Response to Request For Addl Info re Enviro
Qualification (EQ) Special Program

ENCLOSURE 1
RESPONSE TO REQUEST FOR INFORMATION (RAI) ENCLOSURE 1
CONCERNING ENVIRONMENTAL QUALIFICATION (EQ)
SPECIAL PROGRAM

RESPONSE TO NRC REQUEST FOR ADDITIONAL INFORMATION (RAI)
CONCERNING ENVIRONMENTAL QUALIFICATION (EQ)
SPECIAL PROGRAM

FIG. 1

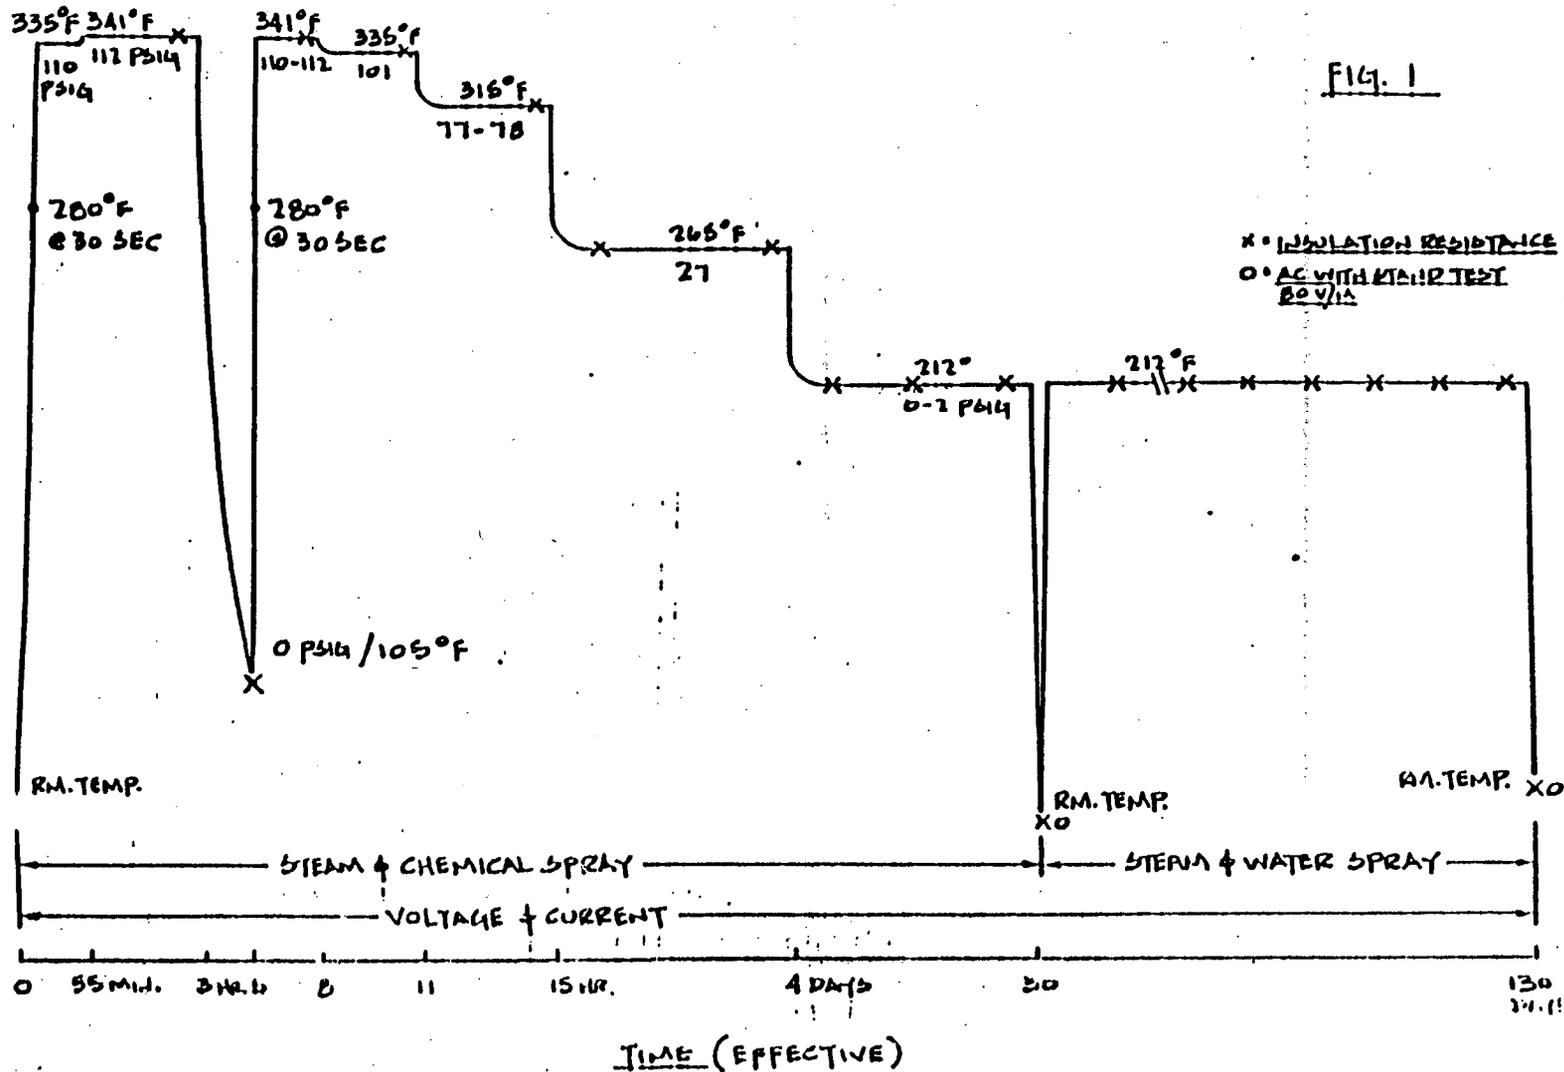
The NRC reviewer questioned whether insulation resistance measurements were taken during the LOCA test and if the leakage current values were identified (EQ binders as denoted in RAI Enclosure 3).
